St. Lucie Unit 1 and Unit 2
Docket Nos. 50-335 and 50-389
Proposed License Amendments
Containment Spray and Cooling Systems

ST. LUCIE UNIT 1 MARKED-UP TECHNICAL SPECIFICATION PAGES

ST. LUCIE UNIT 2 MARKED-UP TECHNICAL SPECIFICATION PAGES

Page B 3/4 6-3

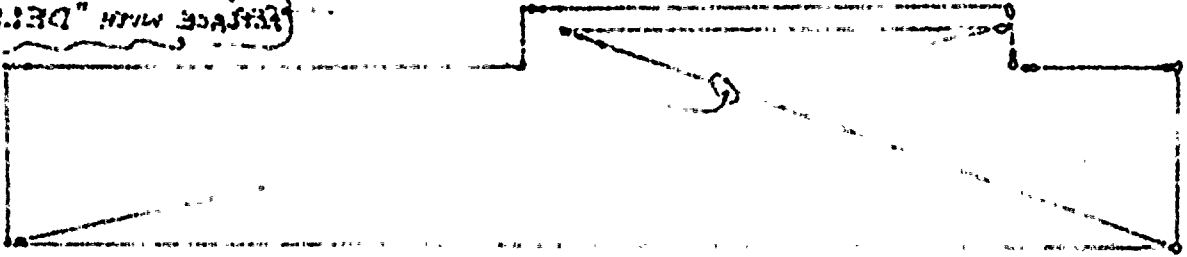
3/4.6.2.3 ~~CONTAINMENT COOLING SYSTEM~~

REPLACE WITH "DELETED"

~~The OPERABILITY of the containment cooling system ensures that 1) the containment air temperature will be maintained within limits during normal operation, and 2) adequate heat removal capacity is available when operated in conjunction with the containment spray systems during post-LOCA conditions.~~

Page 3/4 6-15

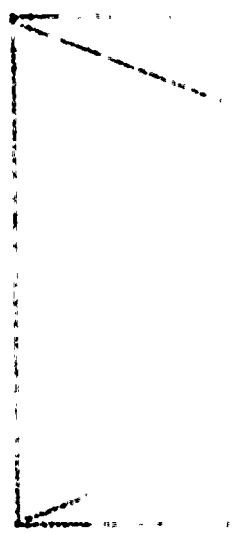
REPLACE
with
INSERT-A

~~Applicable only when pressurizer pressure is > 1750 psia.~~

DELETE

REPLACE
with
INSERT-A

DELETE

3.6.2.1 Two containment spray trains and two containment cooling trains shall be OPERABLE.

APPLICABILITY: Containment Spray System: MODES 1, 2, and MODE 3 with
Pressurizer Pressure \geq 1750 psia.

Containment Cooling System: MODES 1,2, and 3.

- a. With one containment spray train inoperable, restore the inoperable spray train to OPERABLE status within 72 hours and within 10 days from initial discovery of failure to meet the LCO; otherwise be in MODE 3 within the next 6 hours and in MODE 4 within the following 54 hours.

- b. With one containment cooling train inoperable, restore the inoperable cooling train to OPERABLE status within 7 days and within 10 days from initial discovery of failure to meet the LCO; otherwise be in MODE 3 within the next 6 hours and in MODE 4 within the following 6 hours.

- c. With one containment spray train and one containment cooling train inoperable, concurrently implement ACTIONS a. and b. The completion intervals for ACTION a. and ACTION b. shall be tracked separately for each train starting from the time each train was discovered inoperable.

- d. With two containment cooling trains inoperable, restore one cooling train to OPERABLE status within 72 hours; otherwise be in MODE 3 within the next 6 hours and in MODE 4 within the following 6 hours.

- e. With two containment spray trains inoperable or any combination of three or more trains inoperable, enter LCO 3.0.3 immediately.

- a. With one containment cooling train inoperable, restore the inoperable cooling train to OPERABLE status within 72 hours; otherwise be in MODE 4 within the next 6 hours.
 - b. With two containment cooling trains inoperable, enter LCO 3.0.3 immediately
